DELAWARE RIVER BASIN  
LAKE JEFFERSON DAM

SULLIVAN COUNTY NEW YORK  
INVENTORY NO. NY 205

PHASE I INSPECTION REPORT  
NATIONAL DAM SAFETY PROGRAM

Name of Dam: Lake Jefferson (I.D. No. NY 205)  
State Located: New York  
County Located: Sullivan  
Stream: East Branch of Callicoon Creek  
(tributary of Callicoon Ck. & Delaware River)  
Date of Inspection: November 16, 1979

Spillway  
Note deteriorated Concrete  
Photo #3

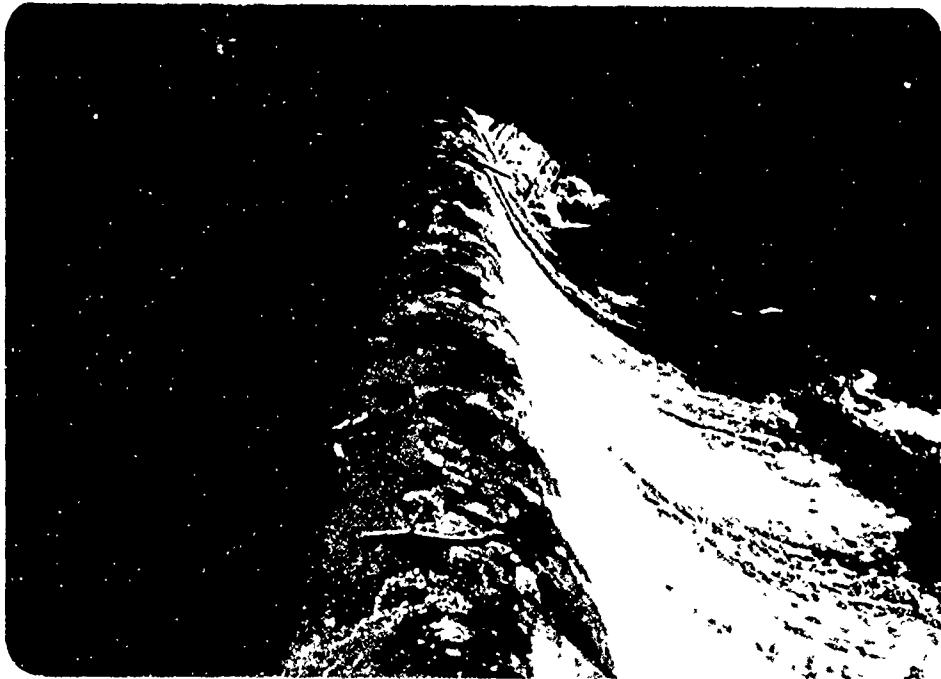
The spillway is concrete covered masonry ogee structure with a bedrock formed downstream channel. (See Photos #1 & 2) The downstream face of the spillway (i.e., concrete covering) is deteriorated, exposing the masonry substructure at numerous locations. (See Photos #3 & 4) The spillway abutment walls are cracked and deteriorated, and the downstream end of the right spillway buttress wall is partially undermined (See Photos #1,2,3,4, &10)

2. The deteriorated concrete of the spillway, core wall cap, spillway buttresses, and core wall requires repair.
3. Remove all tree and brush on the slopes and at the abutments of the earth embankment. Provide a program of periodic cutting and mowing of the embankment surfaces. Also, backfill the animal burrow on the downstream face of the embankment.
